REVISIONS		
No.	DESCRIPTION	DATE
A	Planning Revision	11/11/20 AC AC

PROJECT  
200 THE BROADWAY, YMCA  
LONDON, SW19 1RY

TITLE  
Proposed Site Block Plan

PROJECT	ORIGINATOR	ZONE	LEVEL	TYPE	ROLE	NUMBER
YMCA	DLA	09	DR	A		211

Proposed Site Block Plan

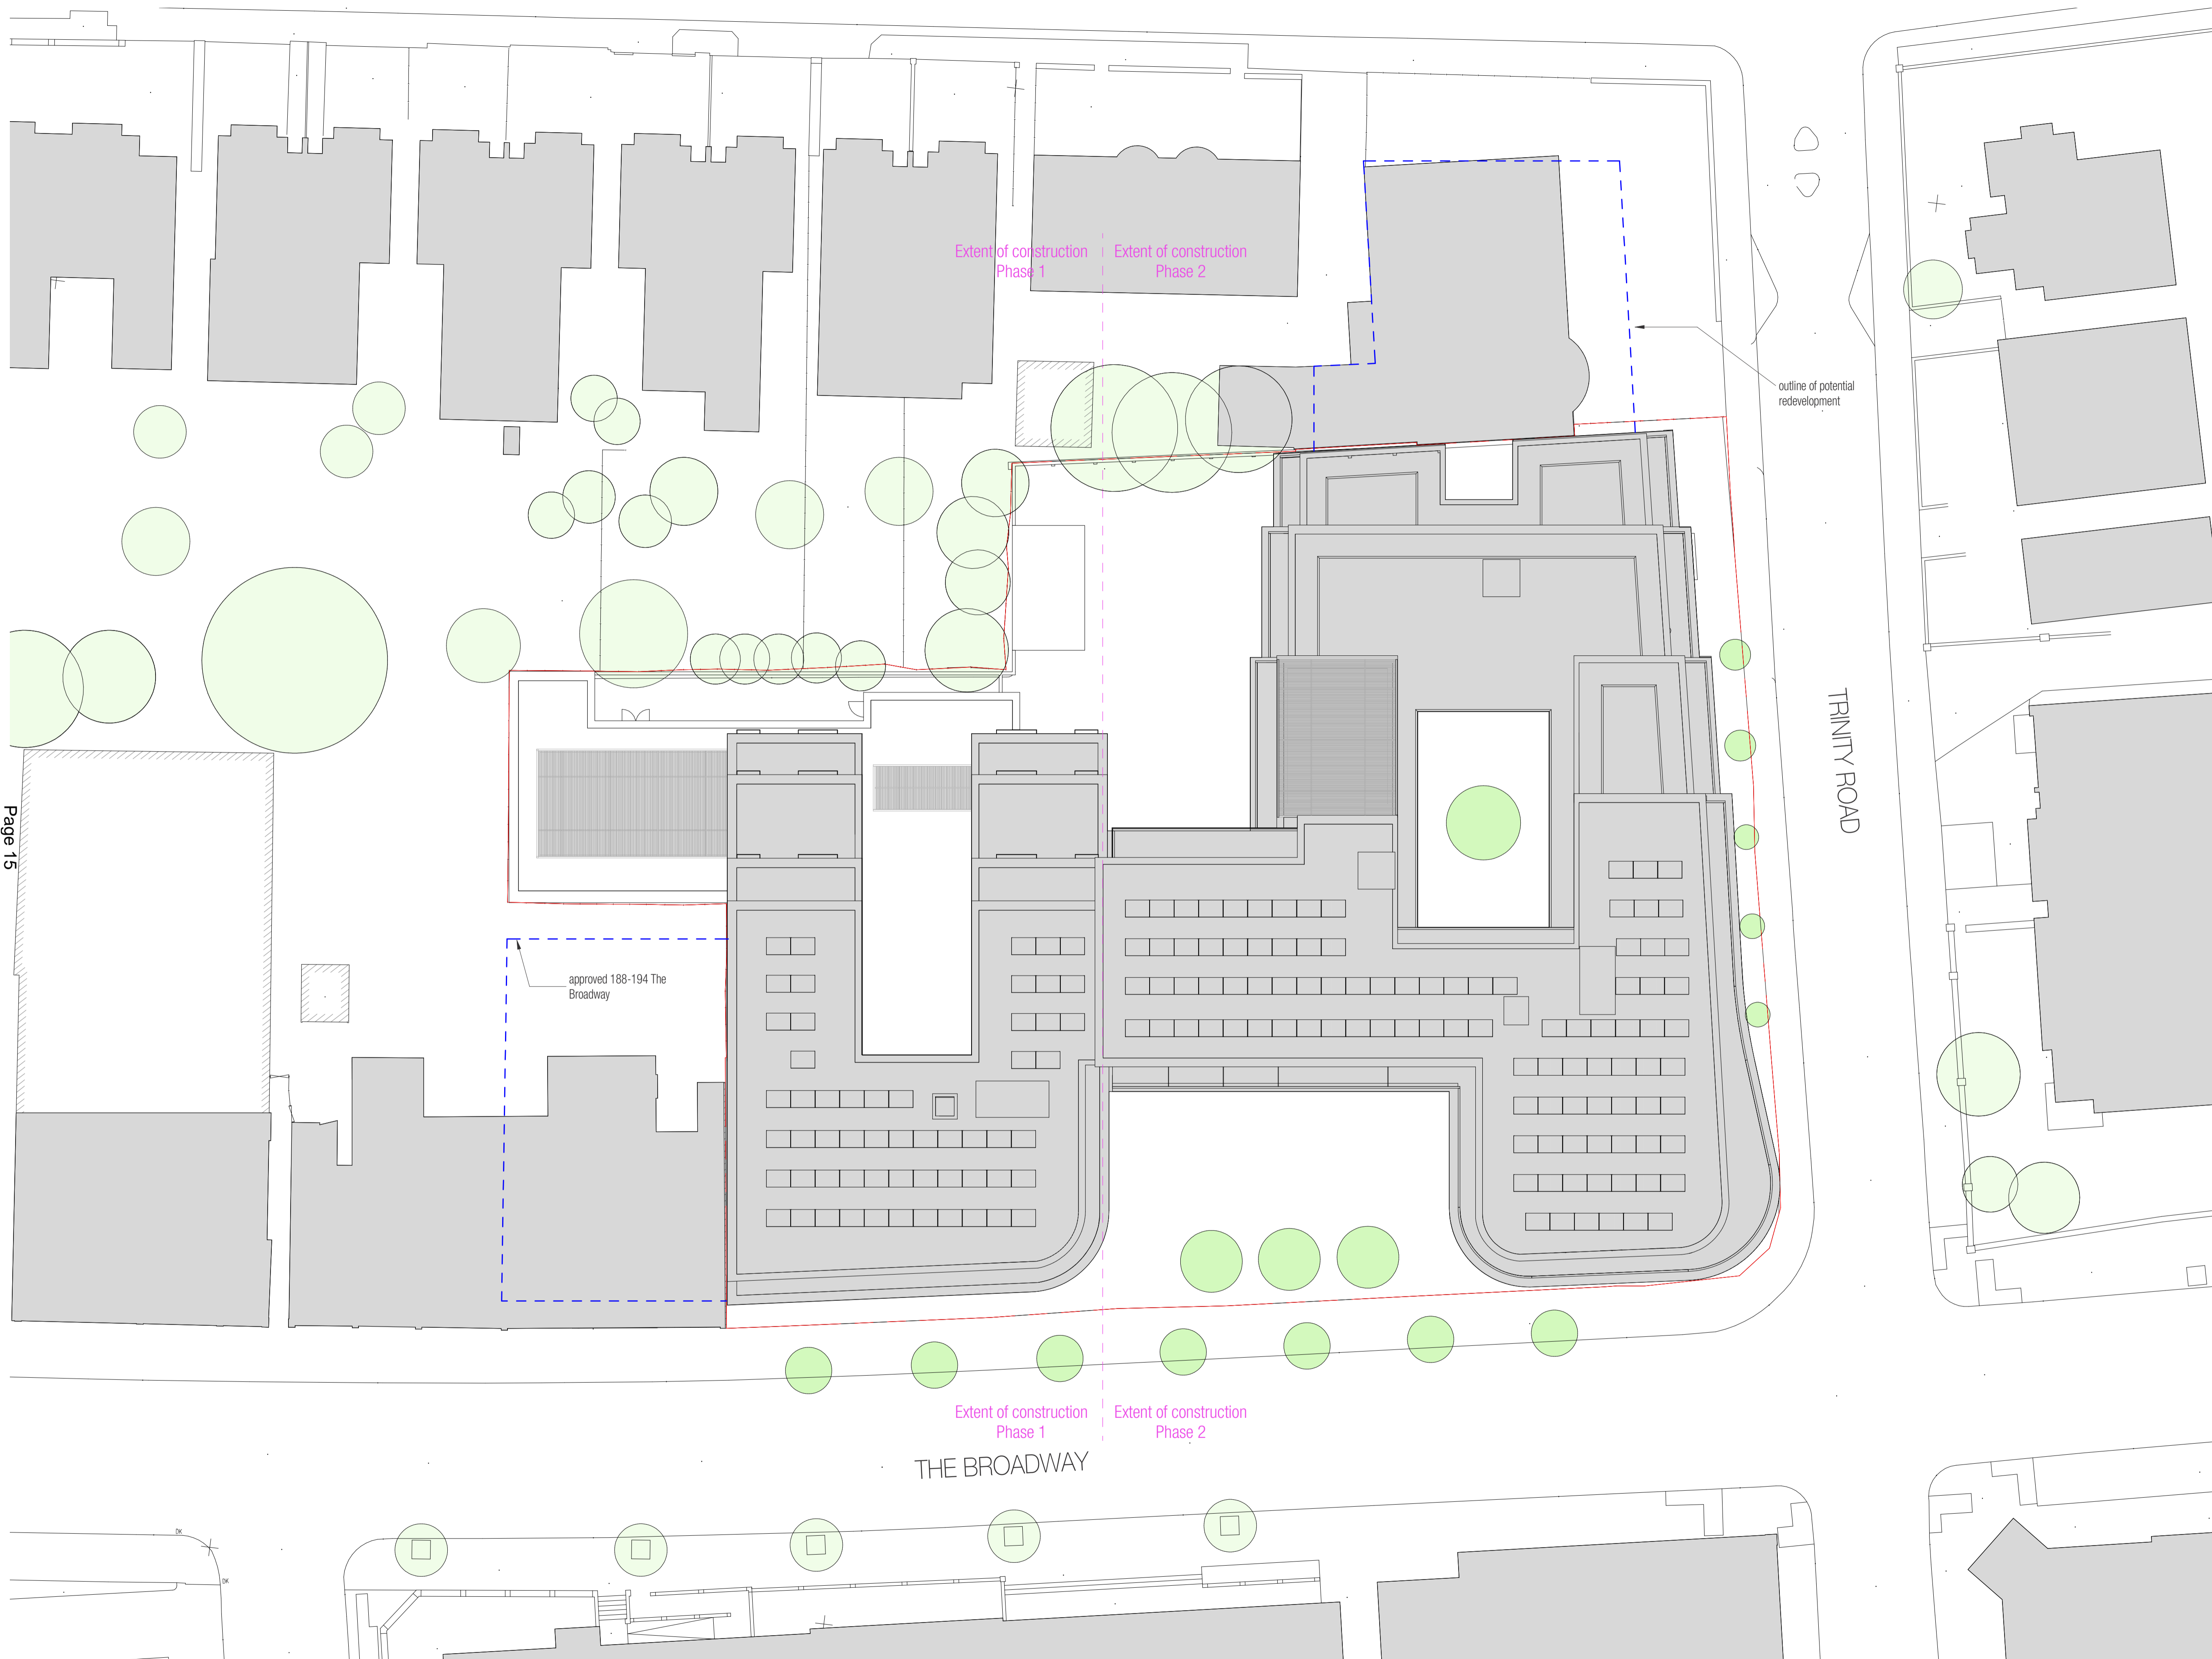
- Reduction in bedroom size in the 1b1p units.
- Addition of 750mm zone around beds in 1b2p central block units.
- Boundary treatment to ground floor duplexes on Trinity Road reduced from 1.5m height to 1.2m.
- Ground floor duplex gardens/bins store reconfiguration.
- Additional side door from servicing corridor to central commercial unit.
- Amendments to the enlarged cycle parking spaces to provide a secured and lockable store.
- Short stay cycle parking relocated from Trinity Road to central piazza.
- Provision of clear link from service yard to residential concierge lobby.
- Windows in YMCA amended to show perforated panels to avoid overlooking.
- Screen aligned with vertical mullions in central block façade facing The Broadway.
